**From:** Neil Duffield  
**Sent:** 31 January 2019 17:13  
**To:** Hilary Saunders  
**Subject:** NYM/20108/0653/FL St Athanasius Monastery Langdale End E62 NYMNP details 31-01-19

- Elliot Consultancy Arboricultural report using new topographical survey showing full extent of trees
- D11161-02F, Floor Plans showing minor design alteration, windows to Lower ground
- D11161-03H, Elevations, added windows also materials to externals altered.
- D11161-04B, Revised existing topographical survey produced to show further trees as noted in Astute Ecology Report
- D11161-05E, Proposed Block Plan/Topo, building moved to prevent encroachment on Car Park
- D11161-06B, Amended site sections following building position change
- D11161-07A, Car Parking drawing

CLIENT:	Coptic Orthodox Patriarchate		
PROJECT:	New church at St Athanasius Monastery		
Drawing:	Proposed Plans		
DRAWING STATUS:	Preliminary		
DRAWN:	C Eynon	CHECKED:	N I Duffield
SCALE @ SIZE:	1:100@ A1	DATE:	18/12/17
DRAWING No:	D11161-02		REV: F

DRAWING No: D11161-06	REV: B
--------------------------	-----------

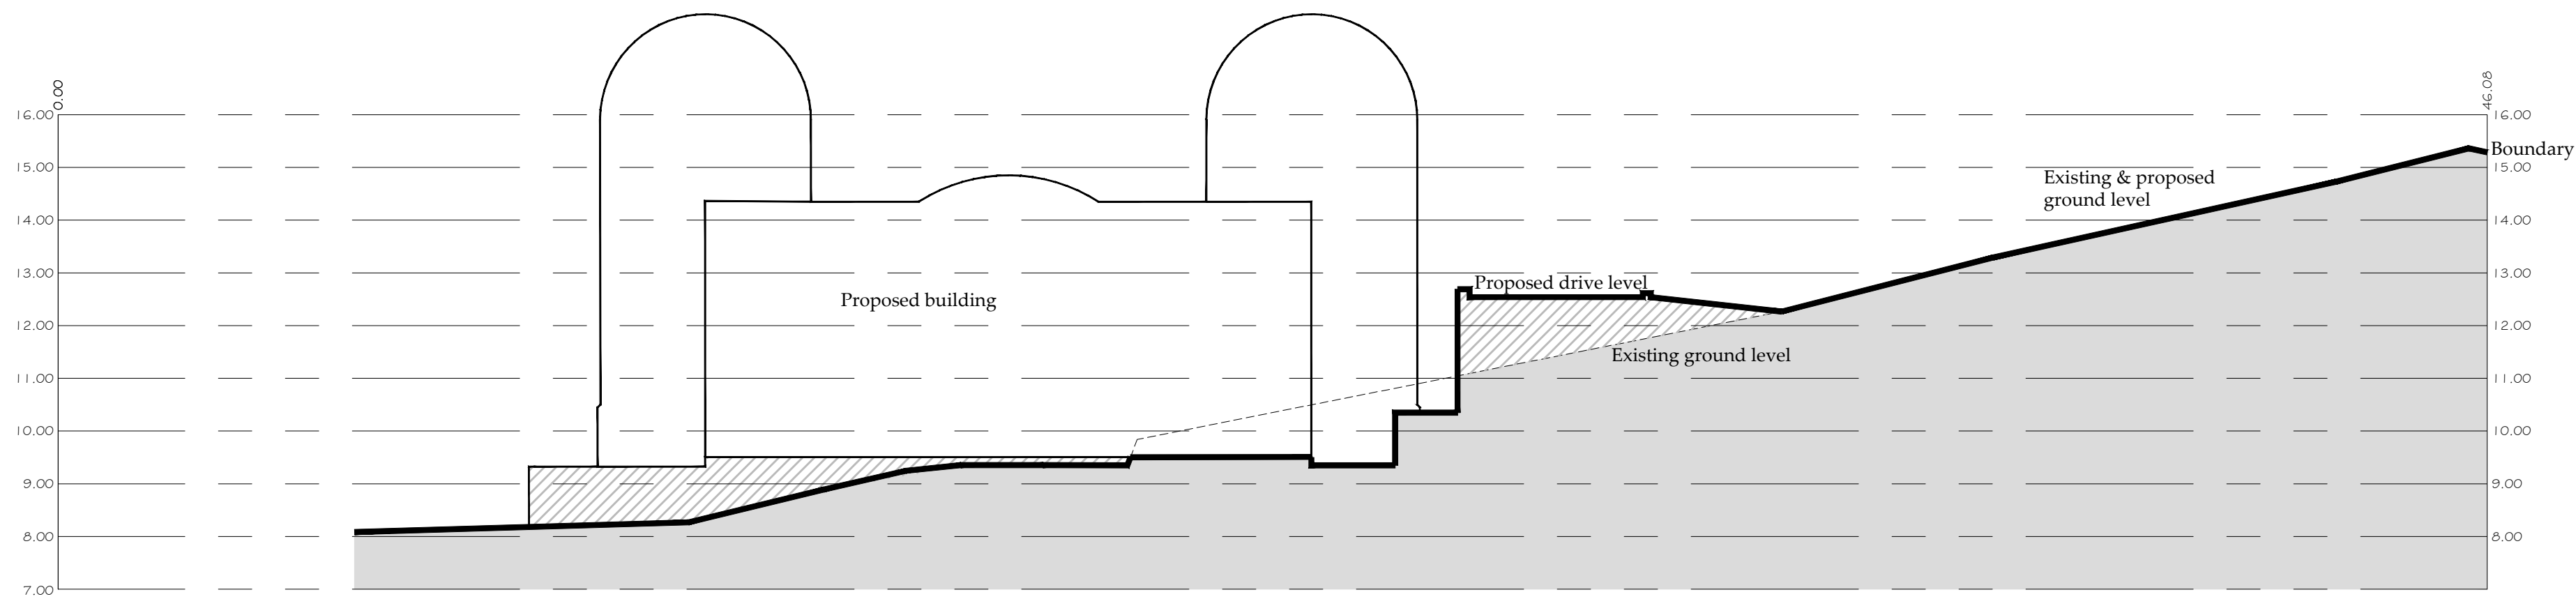
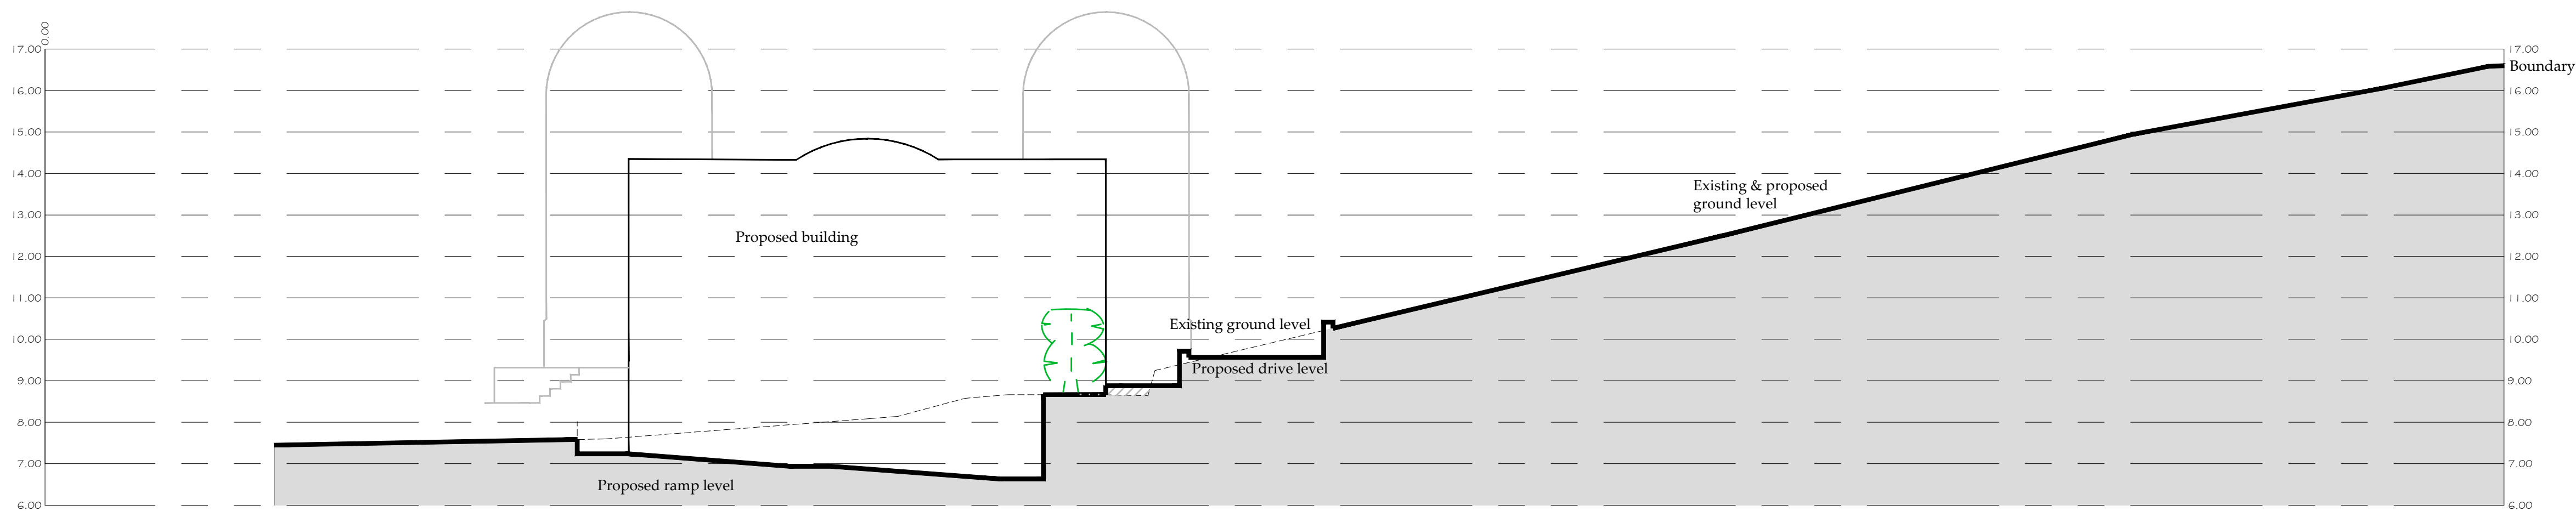
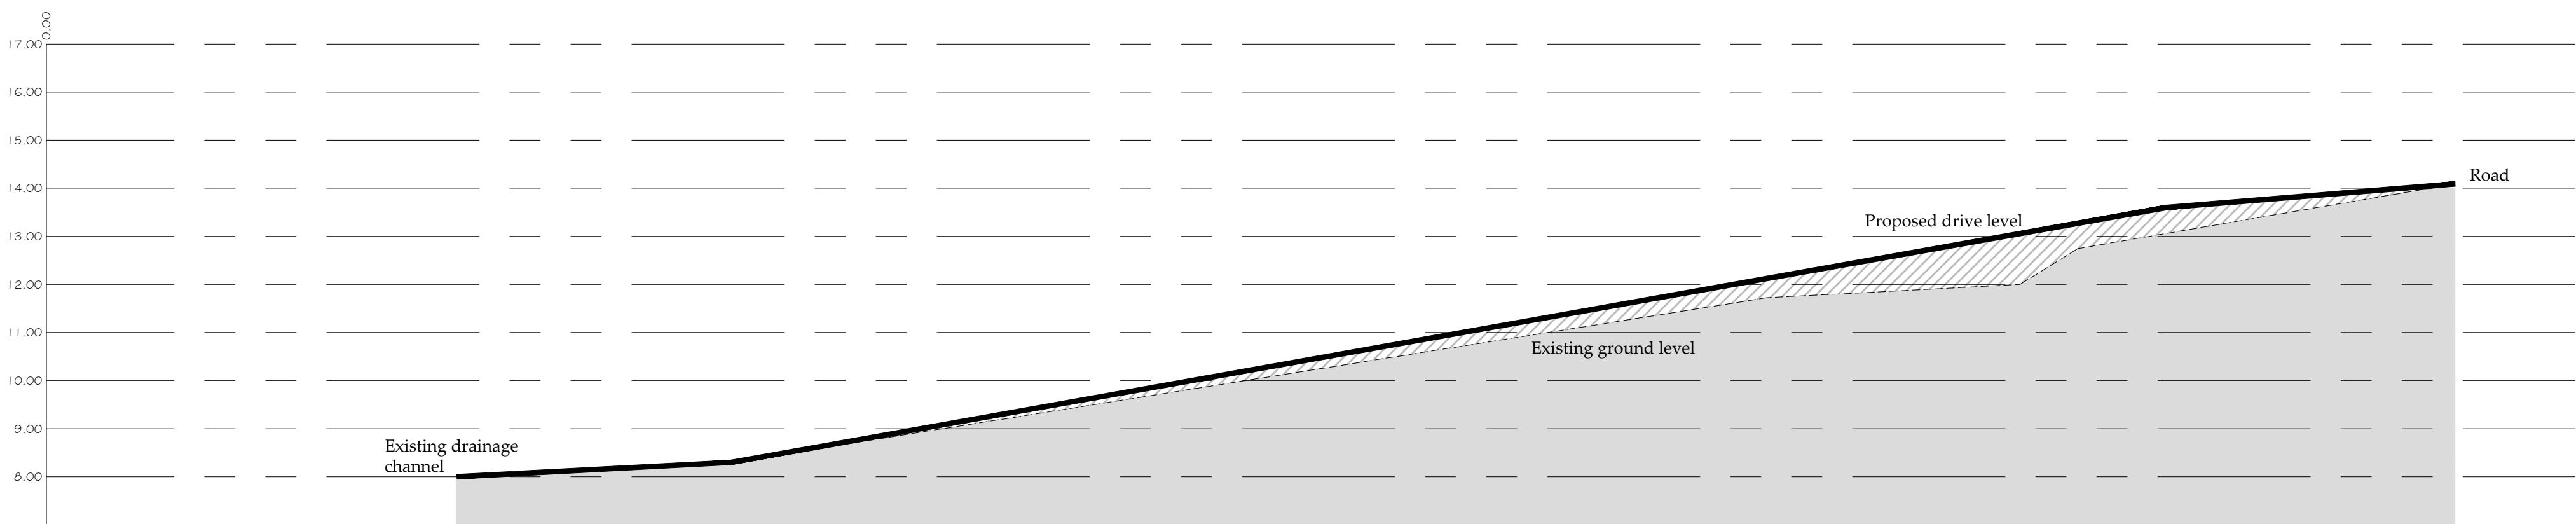
B	15/01/19	CE	Building moved
A	25/09/18	CE	Issued for Approval
